Amendment No. 4

License No. DPR-62

Docket No. 50-324

STAFF SAFETY EVALUATION FOR AMENDMENT 4, CHANGE 4 TO DPR-62

ORGANIZATION OF PLANT
NUCLEAR SAFETY COMMITTEE

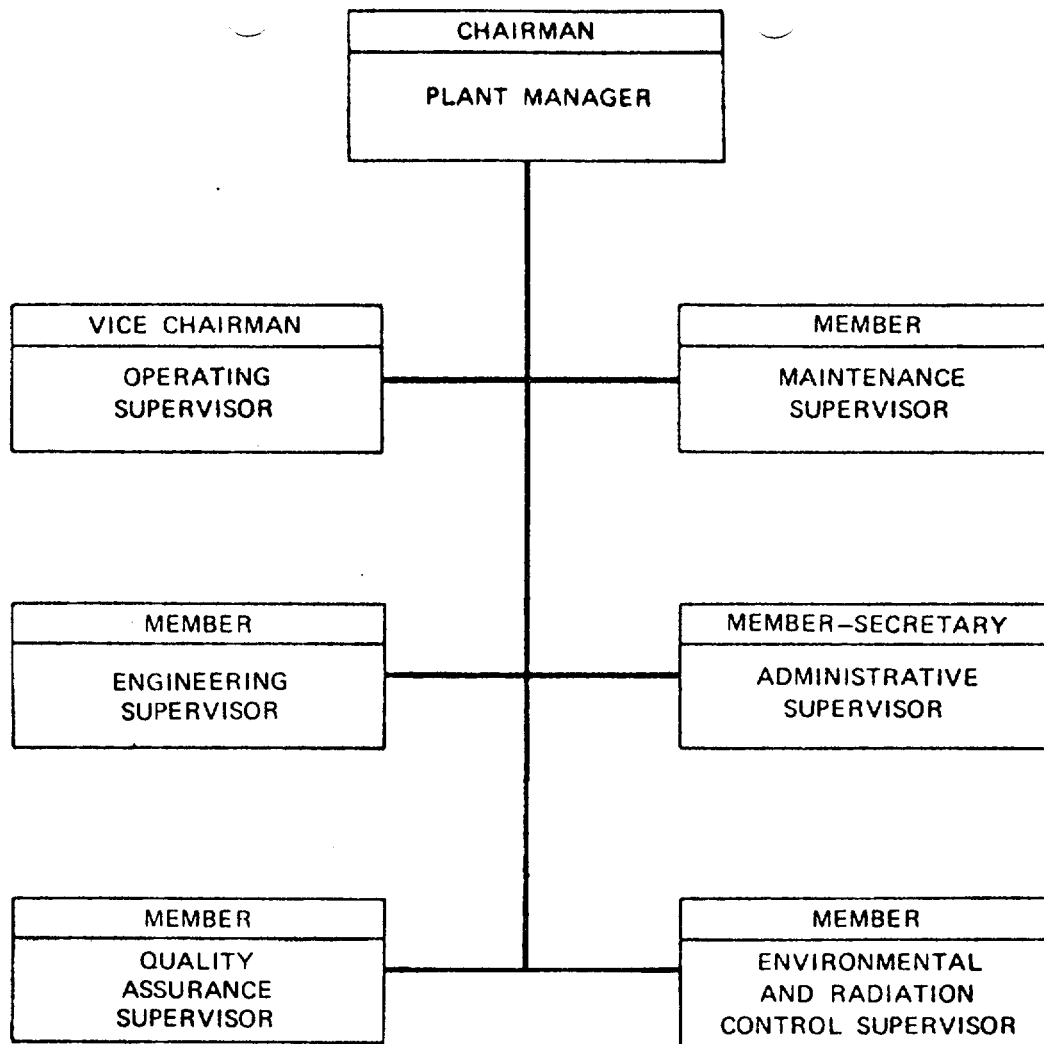
In its letter dated August 5, 1975, the Carolina Power & Light Company requested incorporation into the Technical Specifications for the Brunswick Unit 2 certain recent plant organization changes implemented to increase the effectiveness of the plant's operation and management. We have reviewed these recent changes in plant organization and conclude that they continue to meet our requirements and are acceptable.

As an effective means for regular review, evaluation, and maintenance of plant operational safety, a Plant Nuclear Safety Committee (PNSC) will be established during the preoperational test period prior to fuel loading of the first unit. The committee will be chaired by the Plant Manager and composed of plant supervisory personnel. The organization of this committee is shown on Figure 6.5-1.
